State of New Mexico
Energy, Minerals and Natural Resources Department

New Mexico Oil Conservation Division approval and conditions listed below are made in accordance with OCD Rule 19.15.7.11 and are in addition to the actions approved by BLM on the following 3160-4 or 3160-5 form.

SUNDRY NOTICES AND REPORTS ON WELLS
Do not use this form for proposals to drill or to re-enter an abandoned well. Use form 3160-3 (APD) for such proposals.

Re: Permanent Abandonment
Well: 212 Rincon Unit

Rincon Unit 212 Rio Arriba County, New Mexico PROPOSED P&A

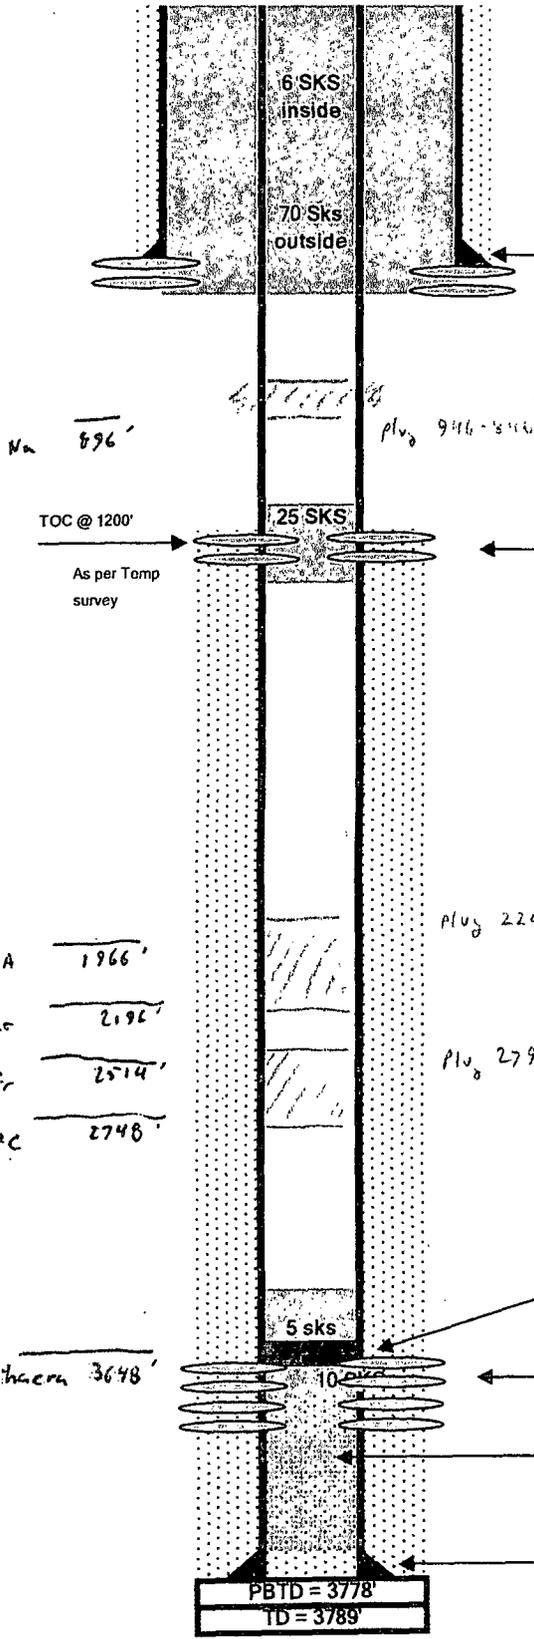
Extend Fruitland plug up to 2425 feet

plug retrieved Cliffs/Fruitland
from 2298' - 2464'
plug Kirkland/Ojo Alamo
from 2246' - 1916'

1. Plugging operations authorized are subject to the attached "General Requirements for Permanent Abandonment of Wells on Federal and Indian Lease."
2. Farmington Office is to be notified at least 24 hours before the plugging operations commence (505) 564-7750.
3. The following modifications to your plugging program are to be made:
 - a) Place the Pictured Cliffs/Fruitland plug from 2798'- 2464'.
 - b) Place the Kirtland/Ojo Alamo plug from 2246'- 1916'.
 - c) Place the Nacimiento plug from 946'- 846' inside and outside the 2 7/8" casing.
